Section 34 Agreement

351-53 New South Head Rd

Ground Floor Plan

Kingsford Property Developments																																																																			
DRAWING TITLE																																																																			
Level 2 Floor Plan																																																																			
JOB NO	DRAWN	SCALE	DRAWING NO.

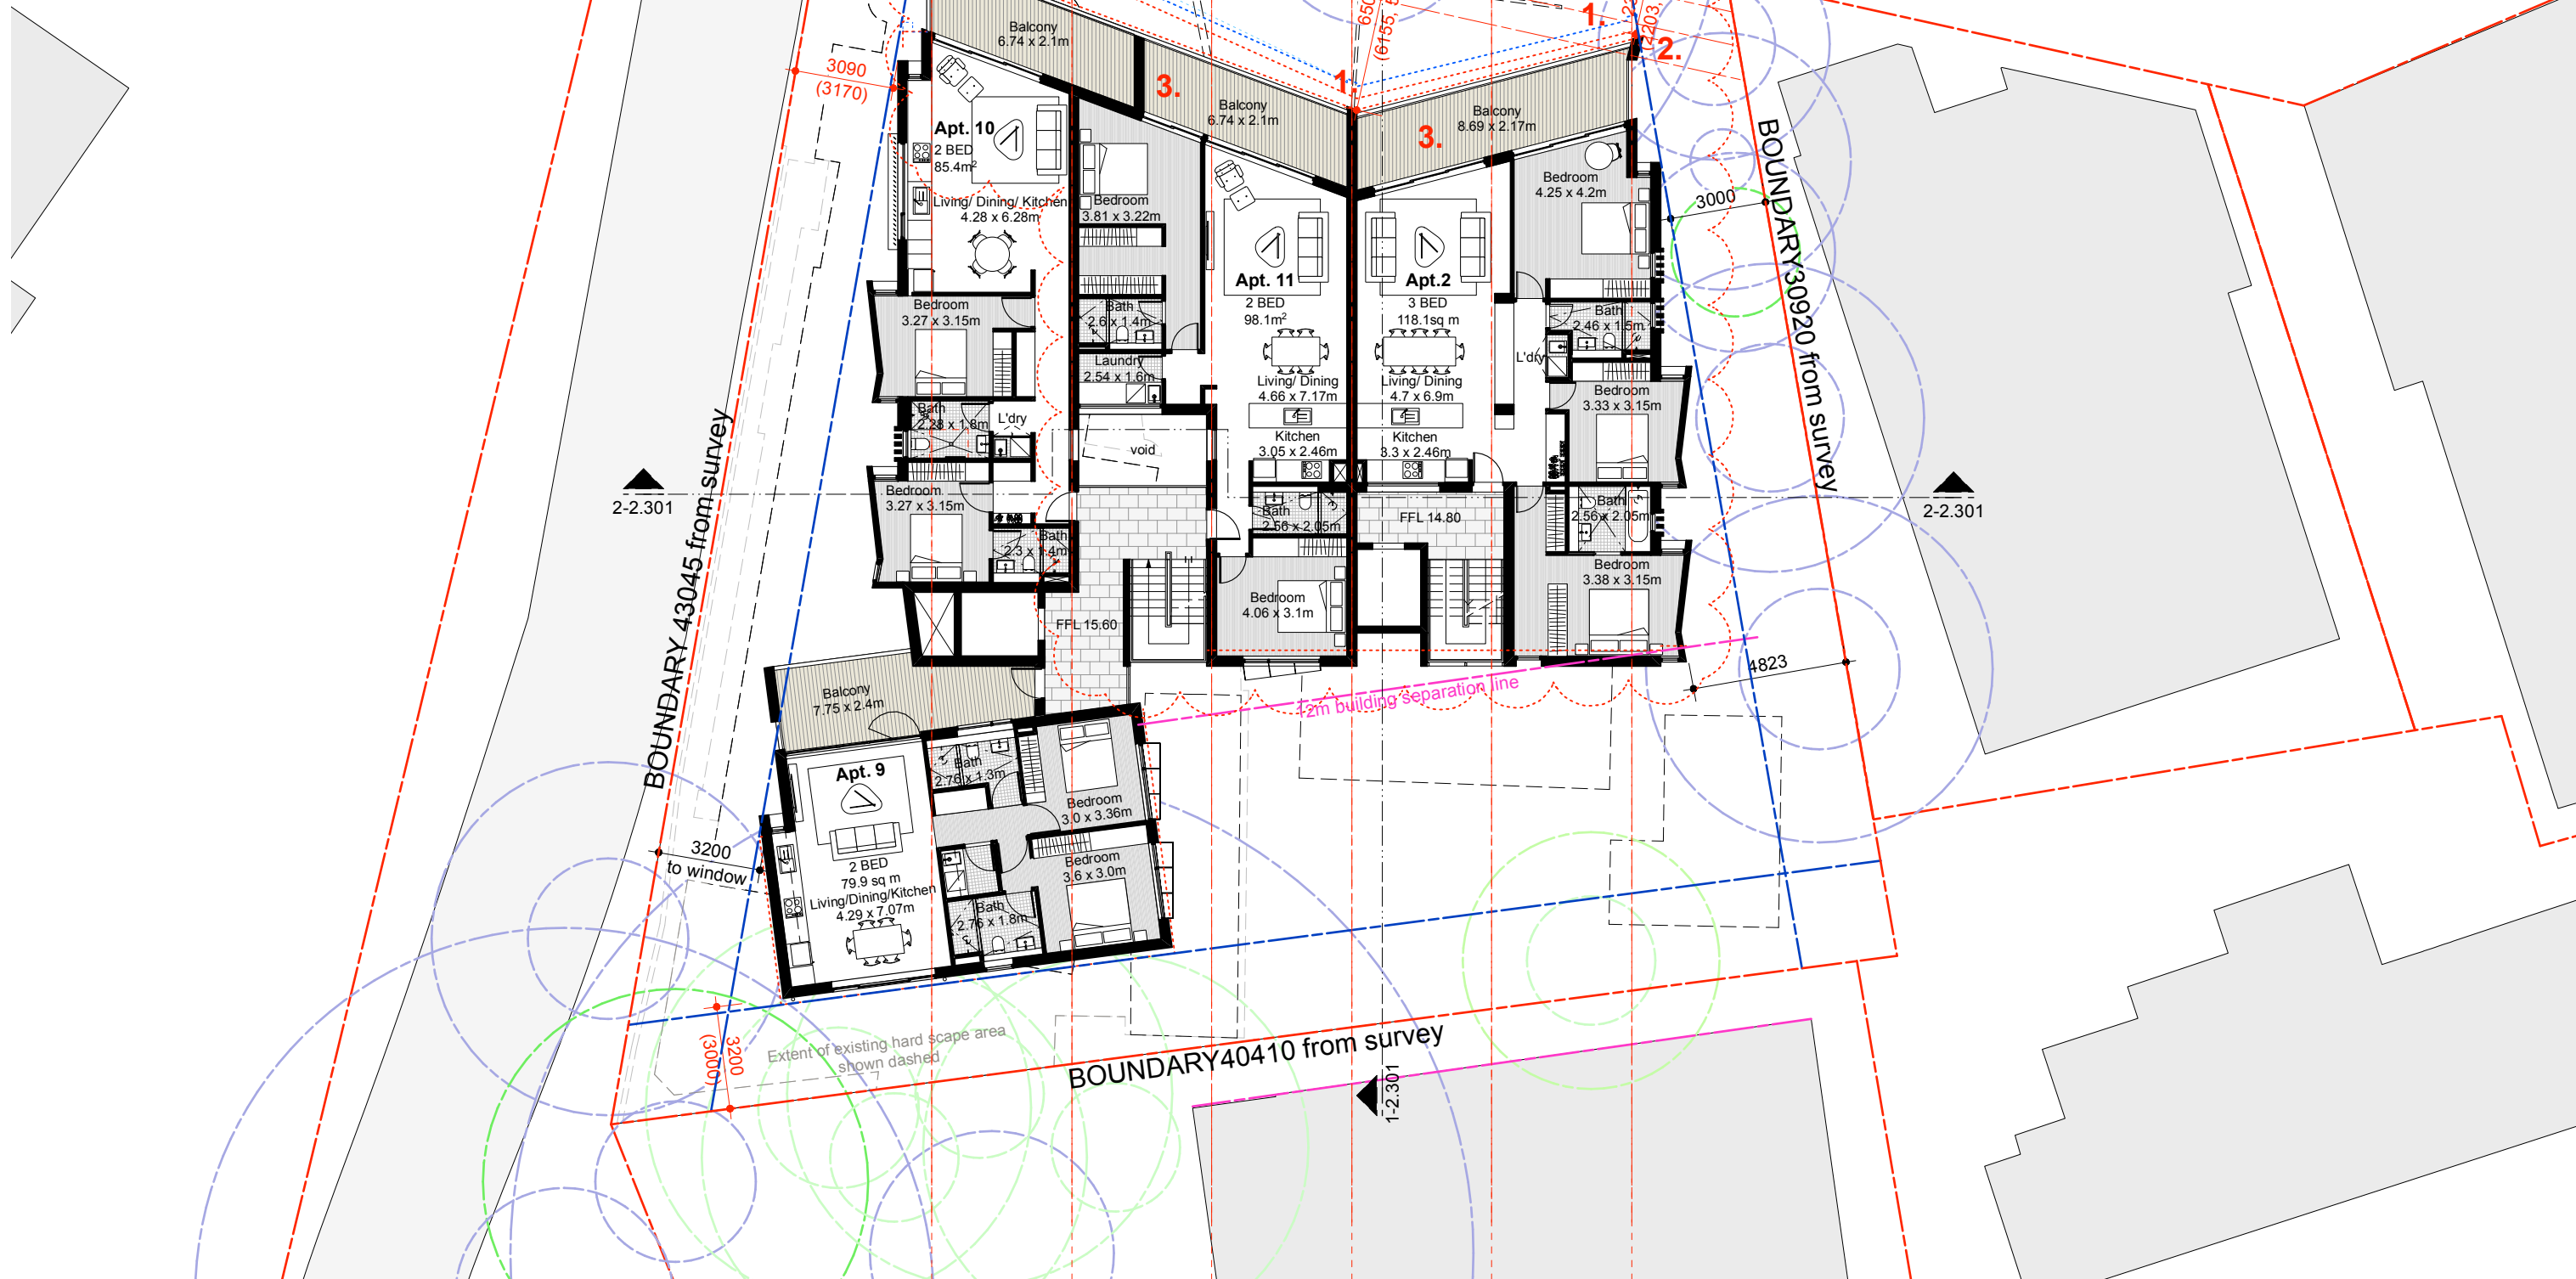
Note:
1. Front setback increased
2. Column size decreased
3. Balcony depth decreased

DRAWING TITLE				Level 4 Floor Plan	
JOB NO	DRAWN	SCALE	DRAWING NO.		
18.41	AR/BD	1:200 @ A3	DA 2.106		
DATE	CHECKED	PLOT DATE	REVISION		
Sept. 18	PT	14/7/21

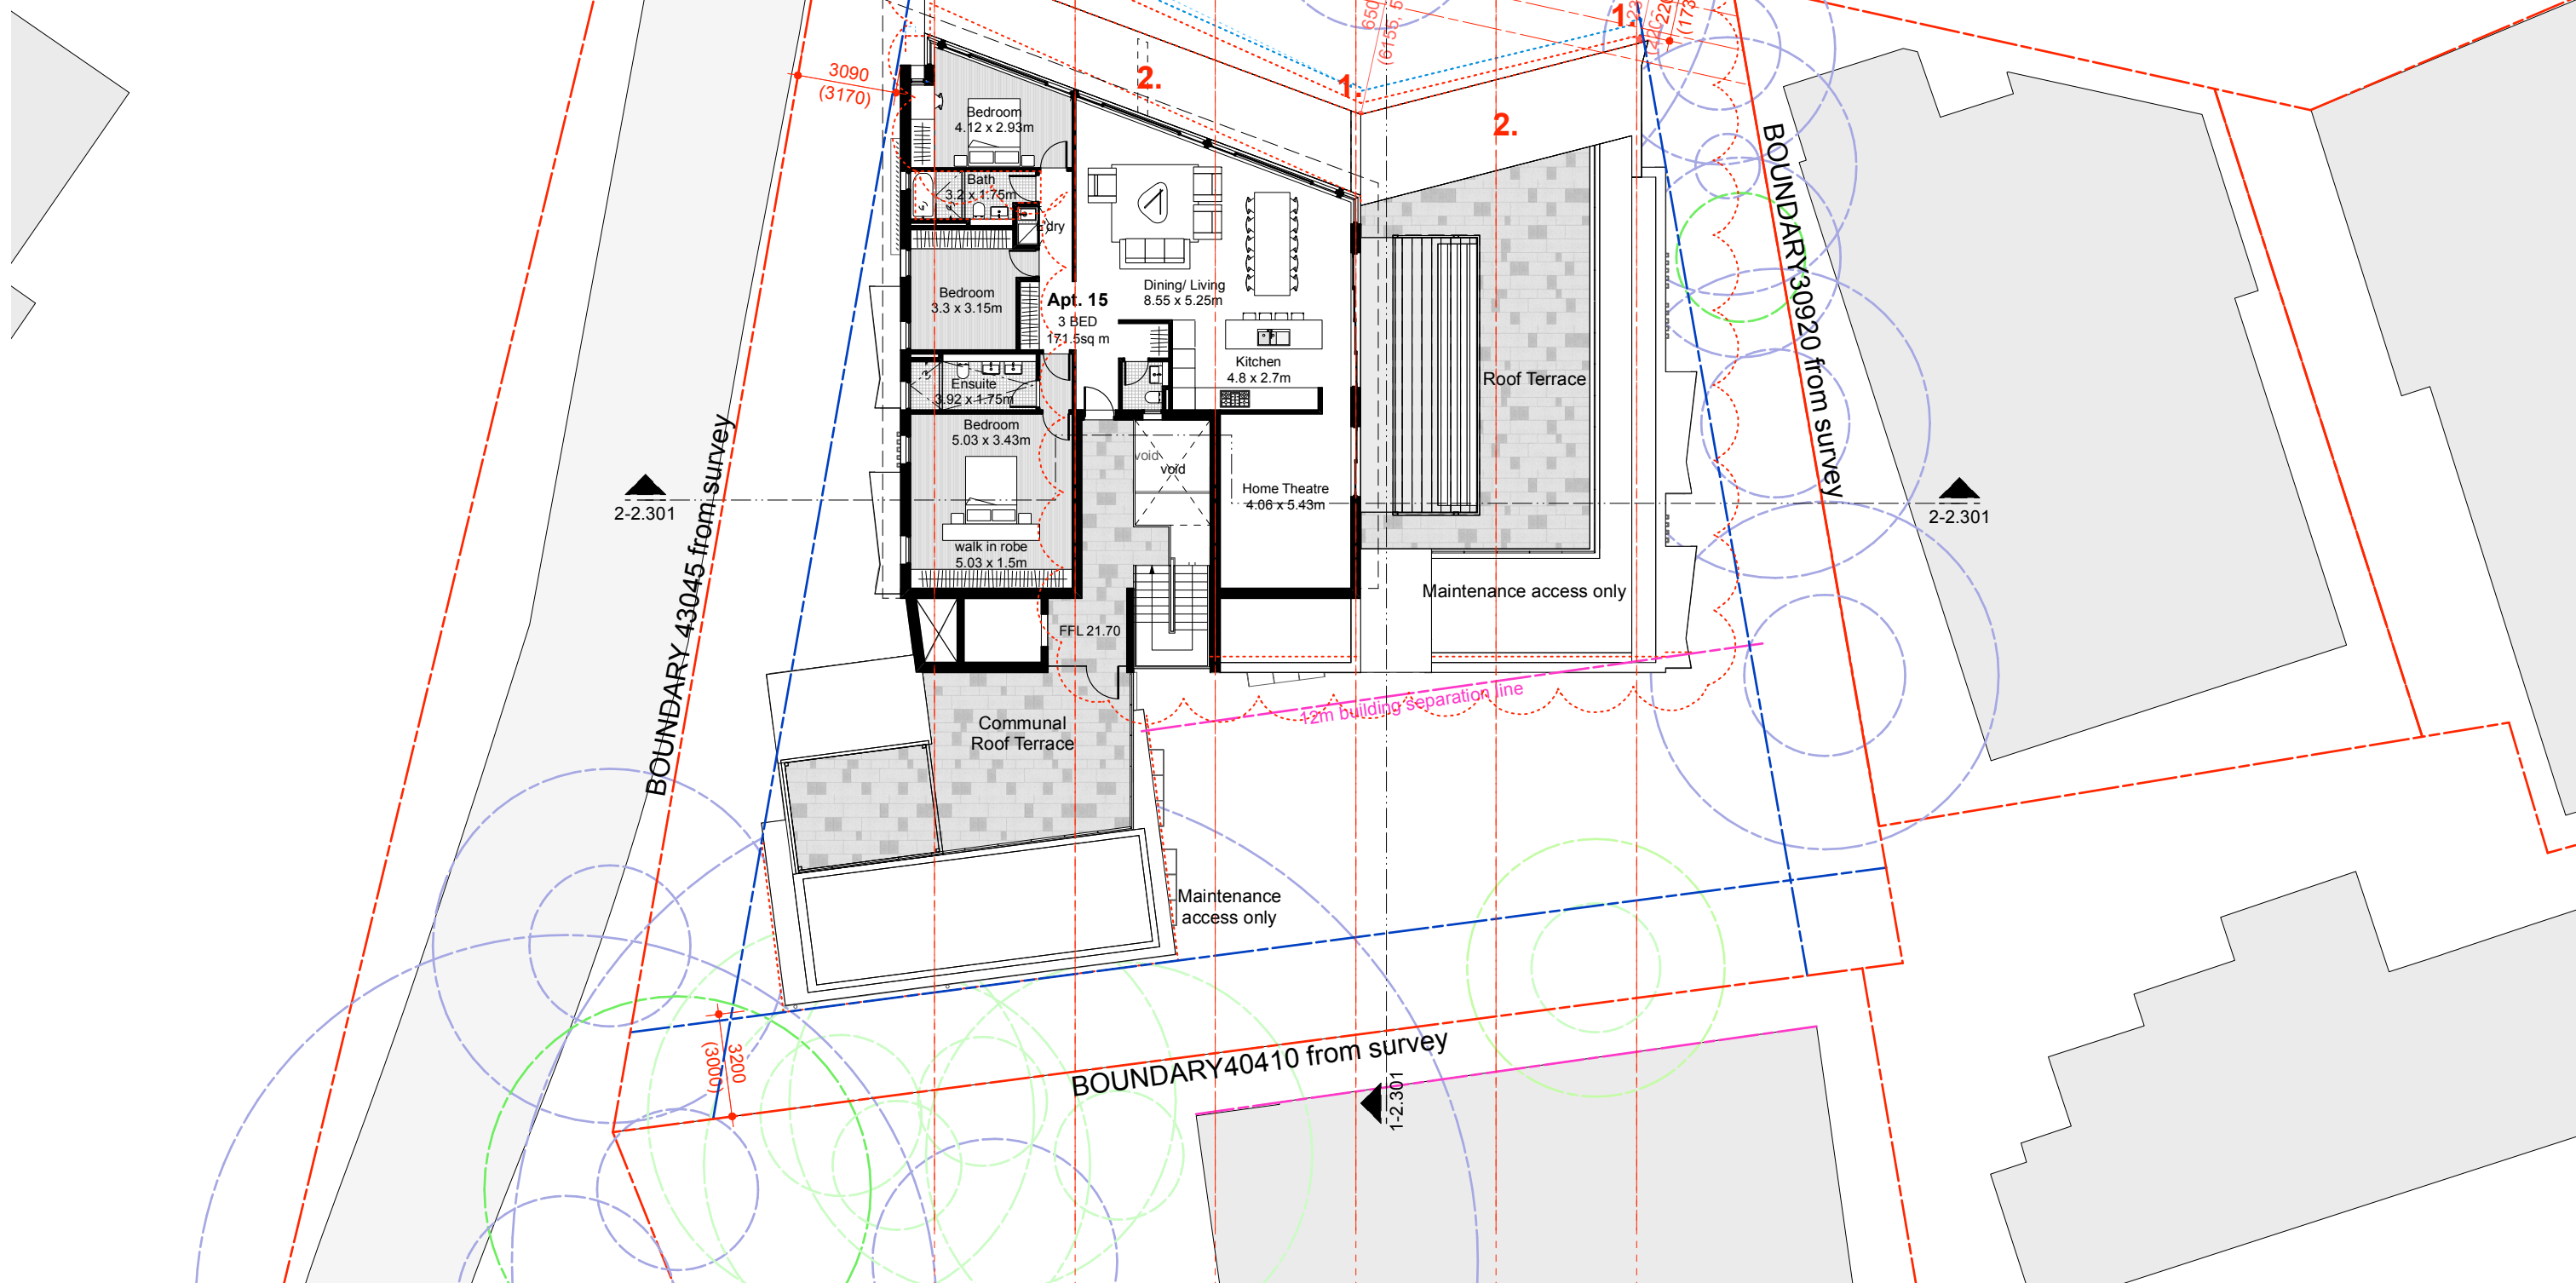
1. Front setback increased
2. Balcony cover decreased

1 North Elevation
Scale: 1:200

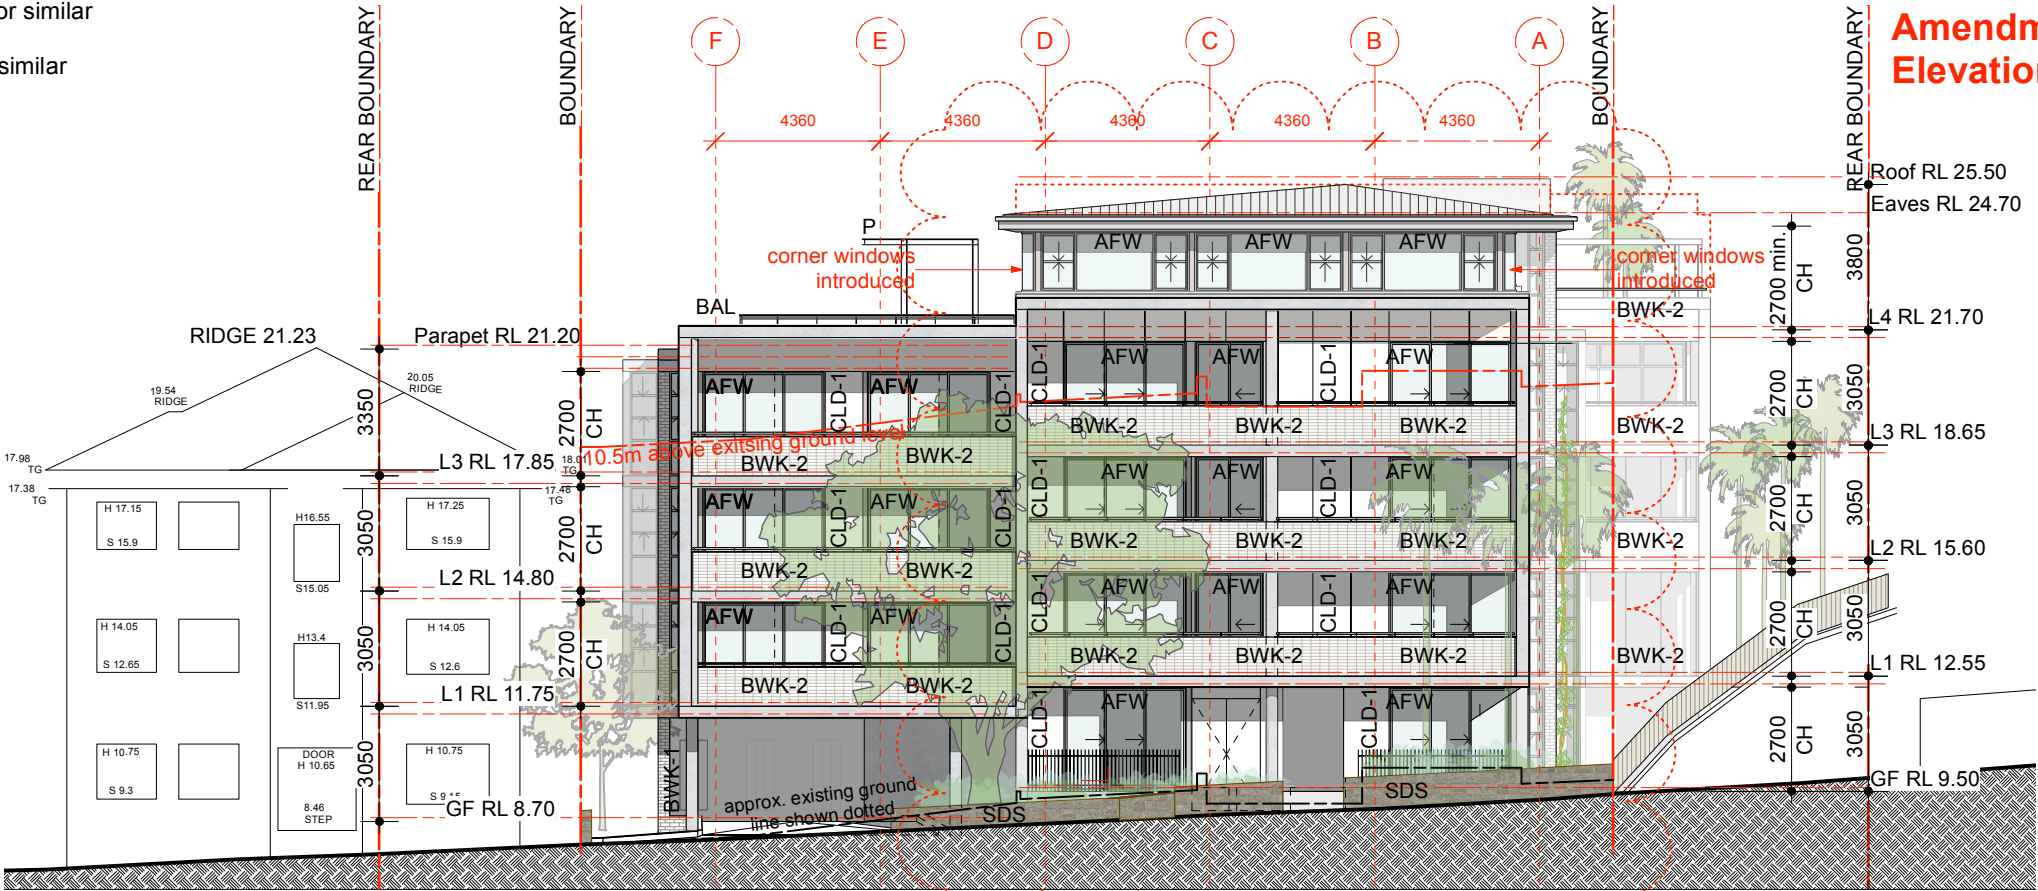
Amendments:
Elevation modified

East Elevation
Scale: 1:200

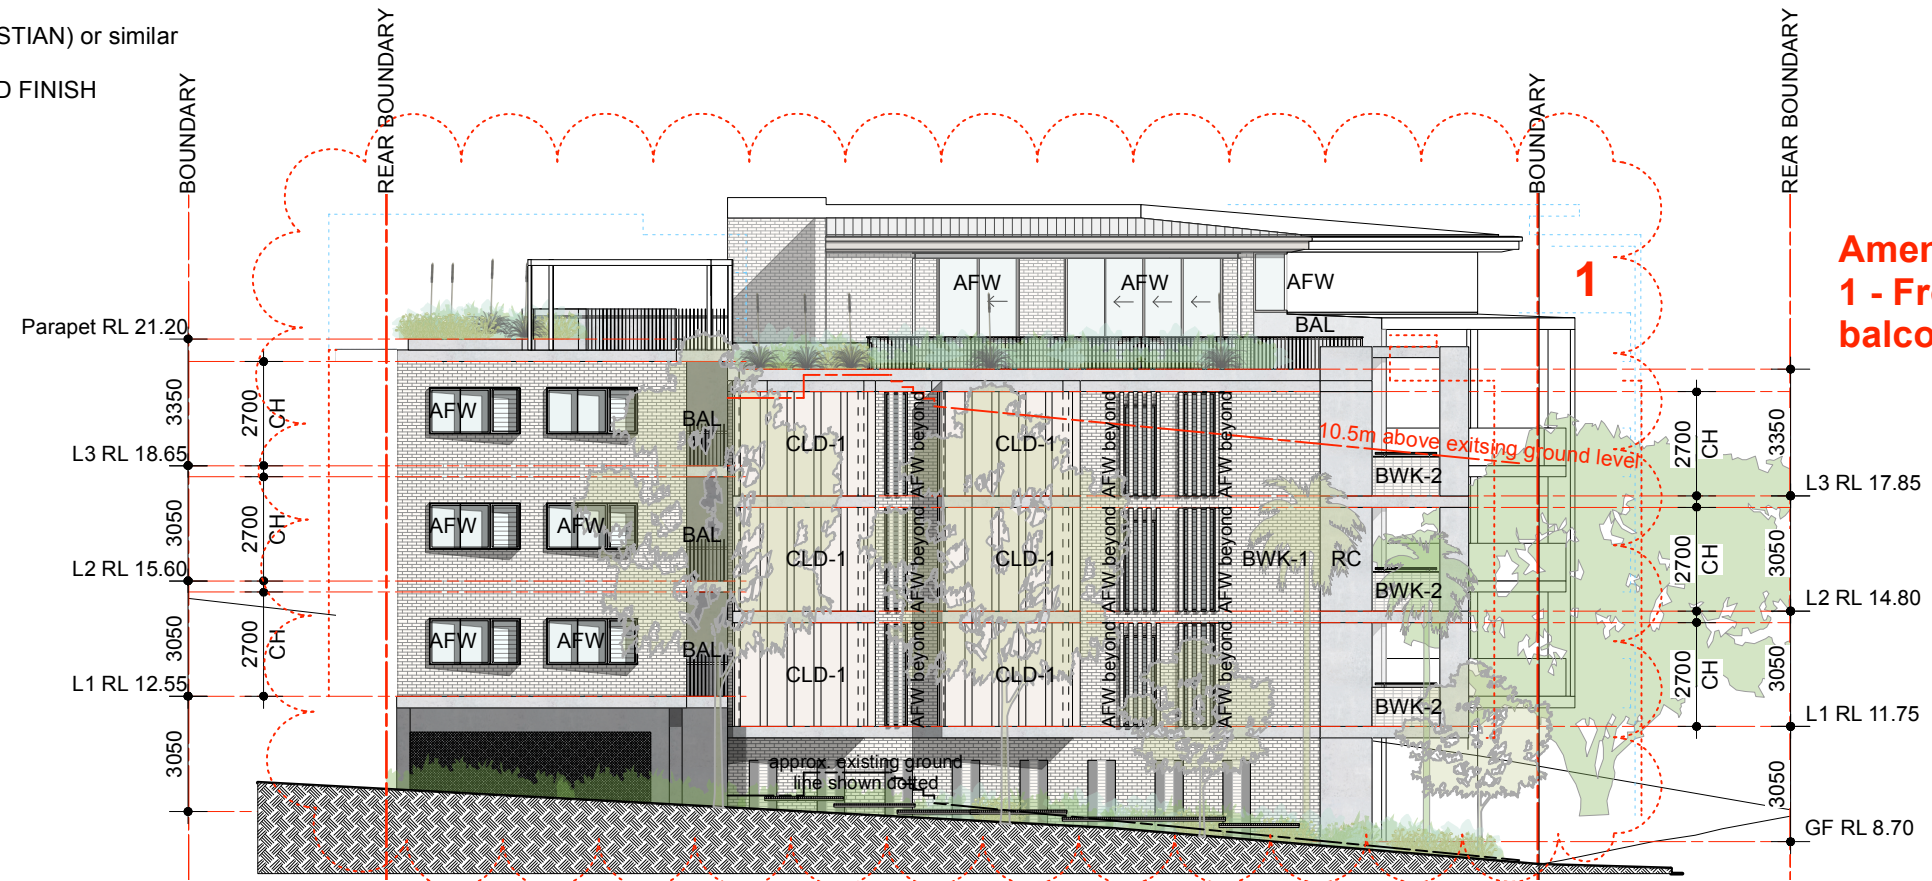
Amendments:
1 - Front setback increased,
balcony depth decreased
